STATE SIGNIFICANT DEVELOPMENT ASSESSMENT

ACCESSIBILITY REPORT

Project: 849-859 Pacific Highway, Chatswood NSW 2057
Document Type: State Significant Development Assessment
Our Reference: P2024_0811-2 (SSDA) YW & DC

Figure 4 – Proposed principal pedestrian access routes

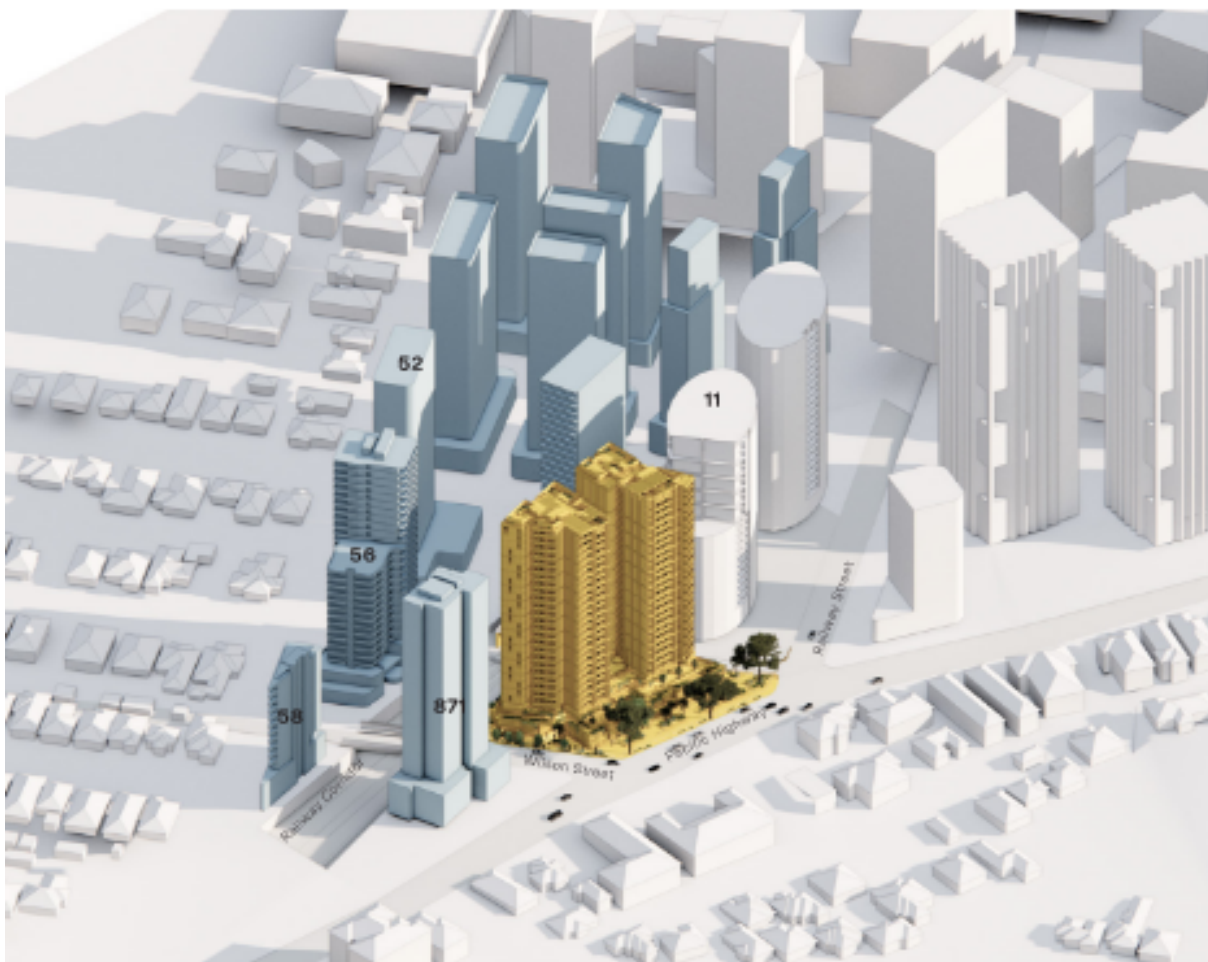
Due to the substantial size of the development site, the travel distance among all pedestrian site entries exceeds 50m and therefore must be made fully accessible. The information provided is adequate for the SSDA.
